<b>Well Name:</b> TELLTALE 11 FEDERAL COM	<b>Well Location:</b> T22S / R27E / SEC 11 / NWSW / 32.4054525 / -104.1651879	<b>County or Parish/State:</b> EDDY / NM
<b>Well Number:</b> 1	<b>Type of Well:</b> CONVENTIONAL GAS WELL	<b>Allottee or Tribe Name:</b>
<b>Lease Number:</b> NMNM64583	<b>Unit or CA Name:</b> CHASE 11 FEDERAL COM	<b>Unit or CA Number:</b> NMNM82109
<b>US Well Number:</b> 3001533954	<b>Operator:</b> DEVON ENERGY PRODUCTION COMPANY LP

**Sundry ID:** 2898306

**Type of Action:** Plug and Abandonment

**Permanent Abandonment of Federal Wells  
Conditions of Approval**

**WELLBORE DIAGRAM - PROPOSED**

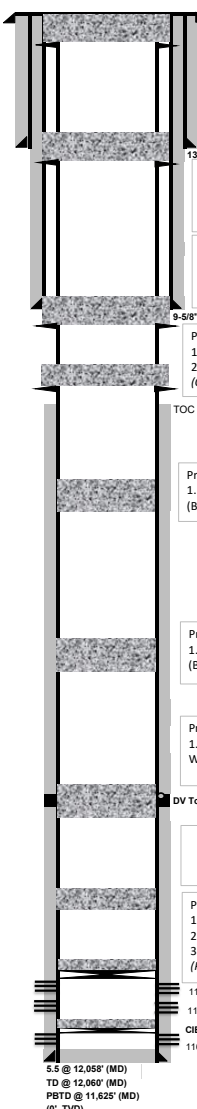
- Perf @ 795'
- Circulate 231 sx Cl C from 795'-surface. (Shoe @ 416', Salado @ 745')

- Perf @ 2266'
- Sqz 65 sx Cl C from 2266'-2090'. WOC & Tag. (Shoe @ 2216', Bell Canyon @ 2143')

- Spot 60 sx Cl C from 4165'-3960'. (Brushy Canyon @ 4115')

- Spot 35 sx Cl C from 5440' to 5266'. (Bone Spring @ 5405')

- Spot 80 sx Cl H w/ 1% calcium from 9004'-8388'. WOC 4 hrs & Tag. (DV Tool @ 8524', Wolfcamp @ 8954')

- Set CIBP @ 11273'. Circ 10# salt gel. Leak test. 500 psi/30 min
- Run RCBL from CIBP to surface. Send to OCD for review.
- Spot 128 svs class H from 11273'-10238'. WOC 6 hrs & Tag (Perfs @ 11323', Morrow @ 11394')

Sundry ID		2898306					
Plug Type	Top	Bottom	Length	Tag	Sacks	Cement Class	Notes
Surface Plug	0.00	100.00	100.00	Tag/Verify			
Fresh Water @ 350	296.50	400.00	103.50	If solid			
Top of Salt @ 393	339.07	443.00	103.93	Tag/Verify

13.375 inch- Shoe Plug Delaware @ 2120	361.84 2048.80	466.00 2170.00	104.16 121.20	Tag/Verify If solid	231.00	C	Perf and circulate from 795' to surface.

9.625 inch- Shoe Plug	2143.84	2266.00	122.16	Tag/Verify	65.00	C	Perf and squeeze from 2266' to 2090'. WOC and Tag.
Bonesprings @ 5390 DV tool plug	5266.00 8388.76	5440.00 8574.00	174.00 185.24	If solid base no need to Tag (CIBP present and/or Mechanical Integrity Test), If Perf & Sqz then Tag, Leak Test all CIBP if no Open Perforations Tag/Verify	35.00	C	Spot cement from 5440' to 5266'.
Wolfcamp @ 8952	8812.48	9002.00	189.52	If solid base no need to Tag (CIBP present and/or Mechanical Integrity Test), If Perf & Sqz then Tag, Leak Test all CIBP if no Open Perforations	80.00	H	Spot cement from 9002' to 8388'. WOC and Tag.
Strawn @ 10392	10238.08	10442.00	203.92	base no need to Tag (CIBP present			
Atoka @ 10690	10533.10	10740.00	206.90	If solid			
Morrow @ 11250	11087.50	11300.00	212.50	If solid			
Perforations Plug (If No CIBP)	11234.02	11448.00	213.98	Tag/Verify

If solid base no need to Tag (CIBP present and/or Mechanical Integrity Test), If Perf & Sqz then Tag, Leak Test all CIBP if no Open Perforations			
<b>CIBP Plug</b>	11238.00	11273.00	35.00		128.00	H	Set CIBP at 11273'. Leak test CIBP. Spot cement from 11273' to 10238'. WOC and Tag.
<b>Perforations Plug (If No CIBP)</b>	11406.28	11622.00	215.72	Tag/Verify			
<b>5.5 inch- Shoe Plug</b>	11889.40	12110.00	220.60	Tag/Verify

Created By	Condition	Condition Date
gcordero	Run RCBL with zero psi, keep hole loaded, log to surface	5/1/2026
gcordero	Spot 25 sacks cement 10472' - T Strawn Spot 25 sacks cement 9972' - T Penn	5/1/2026
gcordero	A Cement Bond Log (CBL) is required to be submitted to electronic permitting.	5/1/2026
gcordero	Submit Cement Bond Logs (CBL) prior to submittal of C-103P.	5/1/2026
